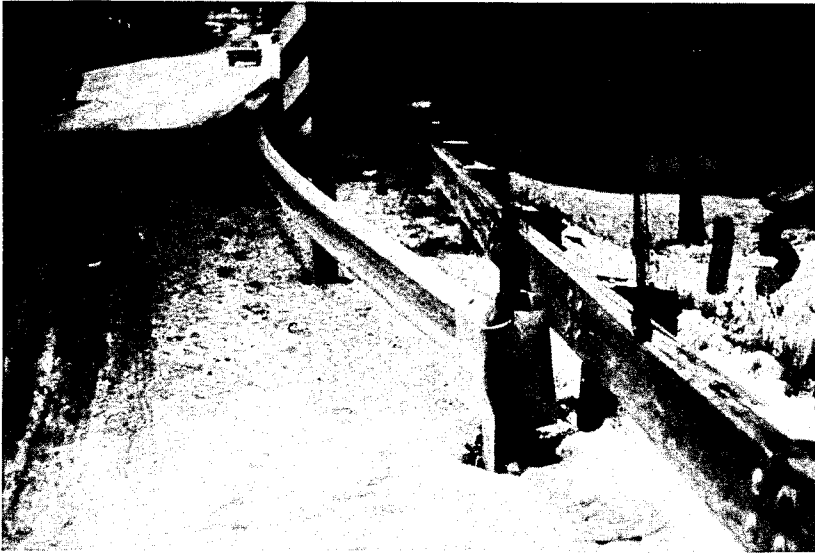
This points out if you bolted this end to the board, a car could slide by. But that 15 inches is enough to grab it.

If you look at this, riding along you think it is a good job; but I went up and took a close view of this.

First, let me point out there is an offset, or bridge abutment, that is not needed. This is a depressed highway and you should not need or have such abutments on depressed highways.
